Access Compliance Report

Public Rights-of-Way

Intersection ID: 30140	Main Street: HARLAND_ST	Cross Street: STREATOR_CT	Location: SE
ADA ID: 08BB00CA72B3	Ramp Type: PerpDiag	Initial Pass/Fail: Fail	Overall Compliance: No
Severity Score: 12.5			
Codes/Mitigation Info/Possible Solution		Field Measurements/Component Compliance

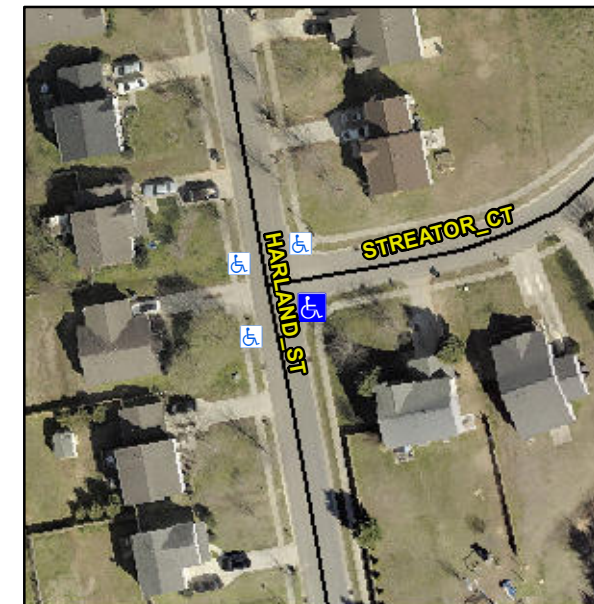
Not Found, R304.5.3

Compliance	Description	Data	Compliance	Description	Data
N/A	Ramp Length (in)	48.0	Yes	Ramp Slope (%)	6.1
Yes	Ramp Width (in)	48.0	No	Ramp XSlope (%)	5.2
N/A	Flare Type LT	N/A	N/A	Flare Type RT	N/A
N/A	Flare Slope LT (%)	N/A	N/A	Flare Slope RT (%)	N/A
N/A	Flare Traversable LT?	N/A	N/A	Flare Traversable RT?	N/A
N/A	Landing Length (in)	N/A	N/A	DWS Provided?	N/A
N/A	Landing Width (in)	N/A	N/A	DWS Contrast?	N/A
N/A	Landing Slope (%)	N/A	N/A	DWS Length (in)	N/A
N/A	Landing X Slope (%)	N/A	N/A	DWS Full Width?	N/A
N/A	Landing Curb? (Y/N)	N/A	N/A	DWS Offset (in)	N/A
N/A	Shared Landing?	N/A			
N/A	Gutter Ponding?	N/A	N/A	Gutter Slope (%)	N/A
N/A	Gutter Lip Ht (in)	N/A	N/A	Gutter X Slope (%)	N/A
N/A	Painted X Walk1?	No	N/A	Painted X Walk2?	No
	X Walk 1 Direction	To N		X Walk 2 Direction	To W
N/A	X Walk 1 Width (in)	N/A	N/A	X Walk 2 Width (in)	N/A
	X Walk 1 Slope (%)	2.0		X Walk 2 Slope (%)	1.2
	X Walk 1 X Slope (%)	0.1		X Walk 2 X Slope (%)	2.4

N/A	Ramp inside XWalk1?	N/A	N/A	Ramp inside XWalk2?	N/A
	Road Slope (%)	4.0	N/A	Clear Space?	N/A
	Road X Slope (%)	2.6	N/A	Clear Space to XWalk (in)	N/A
N/A	Any Obstructions?	N/A	N/A	Storm Grate/Utility Hazard?	N/A
	Obstruction Type			Storm Grate/Utility Type	
		N/A			N/A
		Yes		Surface Condition? (G/P)	Good

Remove & Replace Curb Ramp With Two New Directional Ramps or Equivalent.
